**NUMBER:** 18-003-04

**GROUP:** Vehicle Performance

**DATE:** February 3, 2004

Flash: Poor A/C Performance, Slow Fuel Gauge Response, and Diagnostic Trouble Codes (DTC's) P0341 **\*\*and P1757\*\***

**FIGURE 1 - ENGINE DATA PLATE (2003 AND LATER SHOWN)**

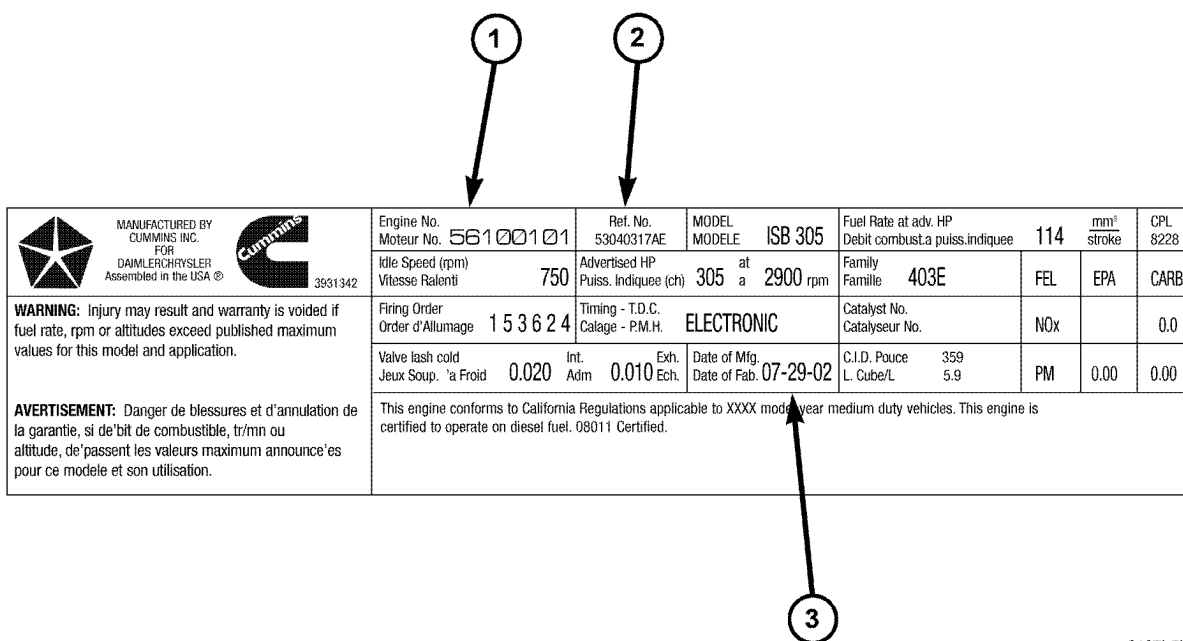
**NOTE:** This bulletin applies to DR vehicles equipped with a Cummins Turbo Diesel engine (sales code ETC or ETH), with an engine serial number **\*\*57130284\*\*** or earlier (Figure 1); and the engine date of manufacture on or before **\*\*December 10, 2003\*\***.

- c. For 2003 and later, if the old part number is not known, highlight the proper calibration based on the Reference No. located in the "Ref. No." box, at the top, center of the Engine Data Plate (Figure 1).
